URGENT Field Safety Notice

IntelliSpace Cardiovascular 6.x, 7.x, and 8.x

Report content may be inaccurate when using Finding Codes to add information

04-Apr-2025

Screenshot 2

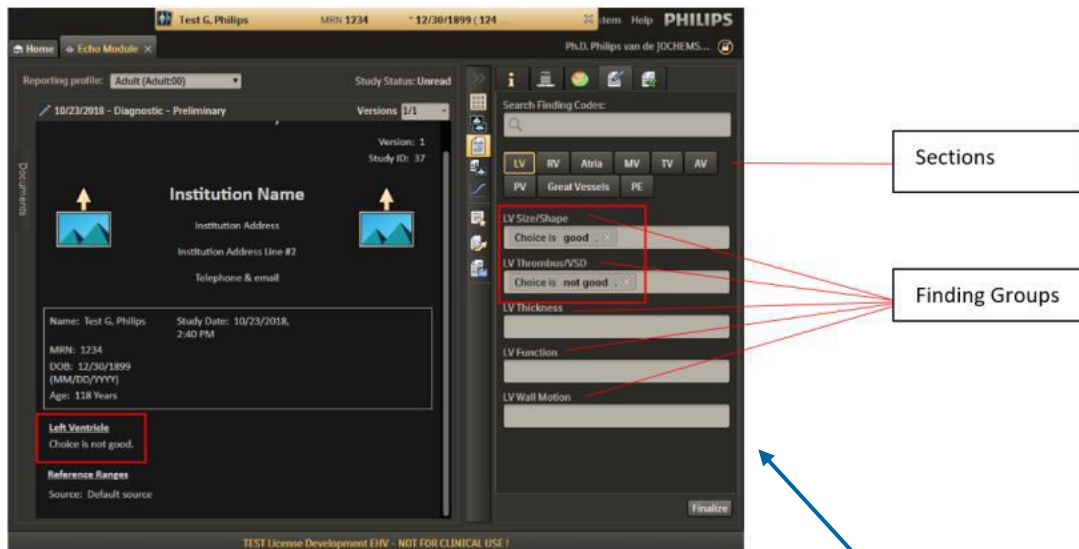
Screenshot 2, In the Echo Module add the same finding code (Choice is_) to the study (in work area interpret sheet), with different Qualifiers (good/not good) i.e. First add 'choice is good' to LV Size /Shape and then add 'choice is not good' to LV thrombus/VSD. Notice in the report (on the left-hand side) only the last added finding code_Qualifier i.e. 'Choice is not good' is added instead of displaying both the finding code_Qualifier ('Choice is good' and 'Choice is not good') from the finding groups. The issue is that the last entered finding code_Qualifier overwrites the previously entered finding code_Qualifier in the report. This is observed in all the sections (LV, RV, etc.).

- Verify that text added into the report conclusion matches the data in the *work area interpret sheet* (Refer to Attachment A Screenshot 2)
- You may continue to use your system(s) in accordance with the intended use and by following the recommendation above.
- Circulate this notice to all users of this device so that they are aware of the potential issue.
- Please retain this letter with your system(s) until a solution is installed on your system; ensure the letter is in a place likely to be seen/viewed.
- Please review the workflows described in Attachment A and identify whether either workflow is currently in use, or planned to be used, at your facility. Please note your response in the attached customer response form.

Screenshot 3

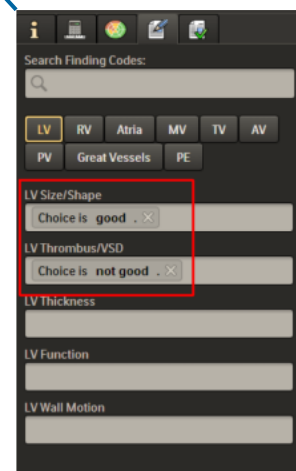
Screenshot 3: Double clicking a finding code_Qualifer, will insert the finding code_Qualifer into the 'Conclusions' section of the work area report sheet (on the left-hand side as shown in the Screenshot). A plus sign (+) is prefixed to the finding code_Qualifer in the finding group to indicate that the finding code_Qualifer has been successfully added into the 'Conclusion.' However, in this example while the finding code_Qualifer has a prefixed plus sign, but it does not appear in the 'Conclusions' section, this is because in this case, the last entered finding code_Qualifier (choice is not good) overwrites the previously entered finding code_Qualifier (Choice is good) in the report. This is observed in all the sections (LV, RV, etc.) however not in between sections (The finding code_Qualifier entered in LV section added to the conclusion will not be overwritten by the finding code_Qualifier that is entered in RV section even if it is entered last in the RV section).
